ALERT SERVICE BULLETIN
Bell Helicopter **TEXTRON**

NO. 206L-07-144

SUBJECT: CARGO HOOK STRESS CORROSION CRACKS

Document No. 159-017-00 Rev 0

Figure 1. Crack location

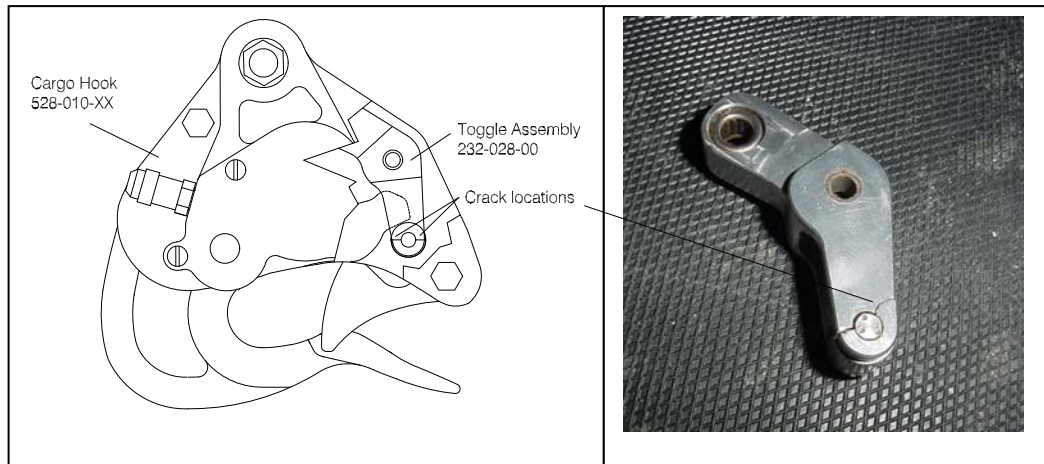
Description: Onboard Systems has had two reported instances of failure of the Toggle Assembly, 232-028-00. The Toggle is an internal component of Cargo Hook 528-010-XX and is a primary element of the Cargo Hook locking mechanism. Figure 1 shows the location of the failure.

Cause: Investigation of the failures has suggested that they were caused by Stress Corrosion Cracking (SCC). Specific mechanical, metallurgical, and corrosive conditions must be present in order for SCC to occur.

In the case of the Toggle Assembly, these conditions were satisfied by—

1. Residual stresses imposed by the press fit of the Load Beam Roller Pin
2. Corrosive salt water environment

1. Visual check to see if cracks are visible in the Toggle. This must be accomplished before further Cargo Hook use and daily prior to external load operations until item 2 is accomplished. If cracks are found, the Cargo Hook must be removed from service and part 2 accomplished before additional use.
2. Replace the original Toggle with a redesigned Toggle, 232-028-01, at the next scheduled overhaul, or within one year from the approval date of this bulletin, whichever comes first.

Figure 2. Crack Locations in Toggle 232-028-00

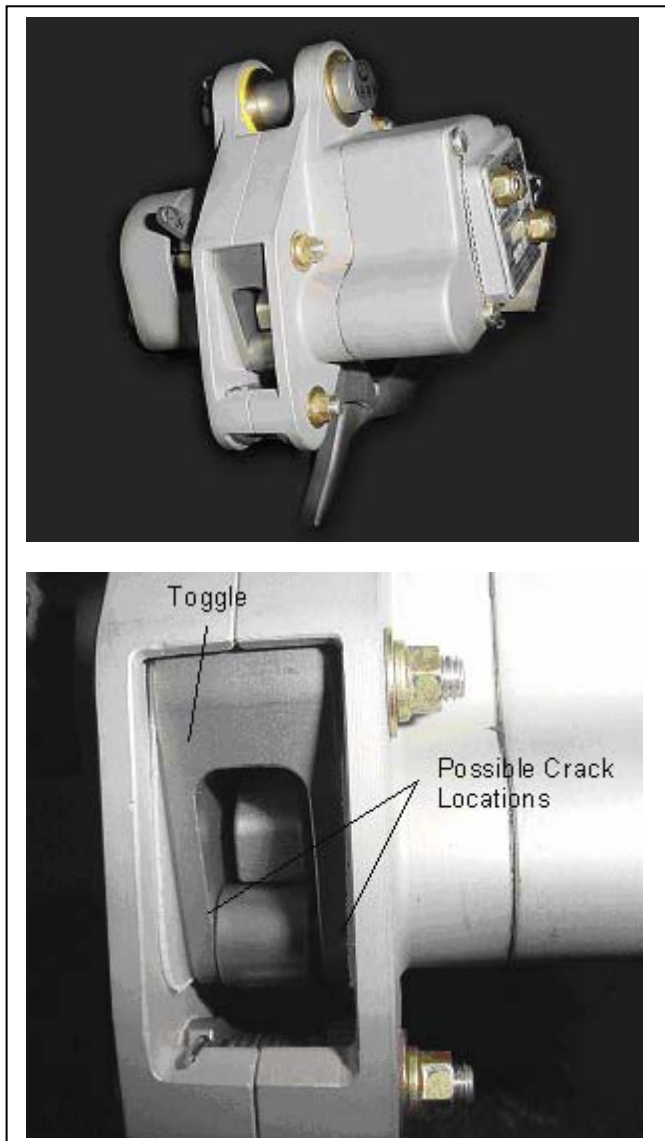
1. Visually check the Toggle for cracking or separation, as viewed in figure 2 in the assembled Cargo Hook.
2. Operate the Cargo Hook per the preflight instructions in the RFMS. If the Cargo Hook does not function properly, it must be removed from service and the part 2 instructions must be accomplished prior to use.

Figure 4. Install New Thrust Plates.

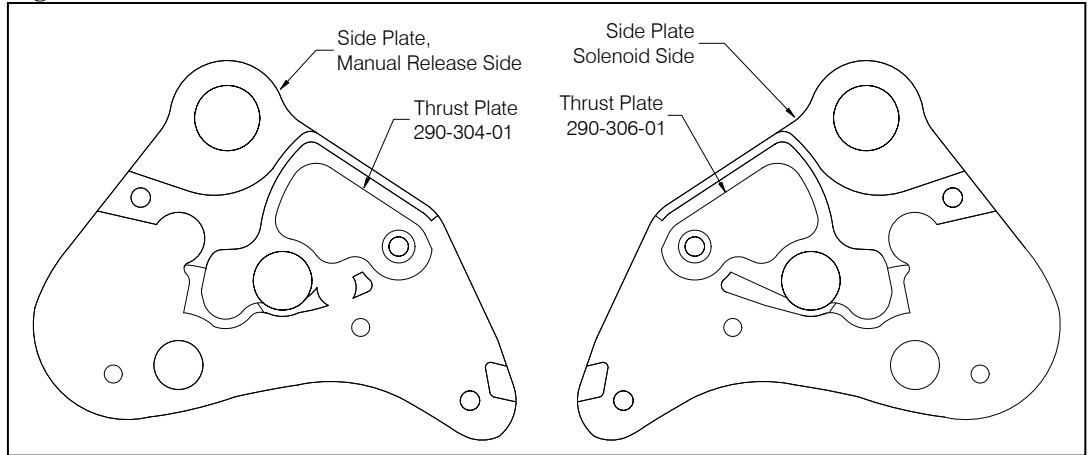
3. Remove Thrust Plates 290-306-00 from the inside of the cargo hook side plate on the solenoid side and 290-304-00 from the inside of the opposite side plate and replace with Thrust Plates 290-306-01 and 290-304-01 respectively as shown in Fig. 4**.

***The Thrust Plates must be replaced or the new Toggle will not function properly.*
